Technical Advisory Bulletin (TAB)

Bulletin #: TBMELCO08A

Product: Melco EMT16, BRAVO

Subject: Power Supply Shunt

Shunt Installation:

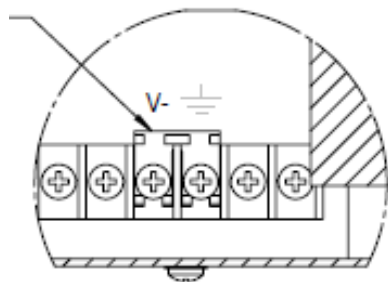
The power supply in the Melco EMT16 and BRAVO machines emits electrical noise into the electrical system of the machine. In some cases the noise level is significant enough that it can impact functionality of electronics, specifically the Thread Break Sensor, on the machine.

Melco implemented a shunt that connects certain terminals on the power supply, which reduces or eliminates the electrical noise transmitted from the power supply into the rest of the electrical system on the machine.

- The shunt Melco part number is 34737 and 34772 (Canada only).
- The power supply shunt was implemented on Melco EMT16 serial number 400954 and up and BRAVO serial number 340360326 and up.

1. Power down the machine and unplug it from the power source.
2. Remove the Lower Arm Rear Cover (34351 or 30526-04) from the machine.
3. Loosen but do not remove the terminal screws marked with “-V” and “ $\perp$ ” (see pictures below).
4. Slide the Shunt (34737 or 34772 for Canada only) over the “-V” and “ $\perp$ ” terminals. See pictures below.
5. Tighten the terminal screws.
6. Reassemble the Lower Arm Rear Cover.
7. Reconnect the machine to power and operate as normal.
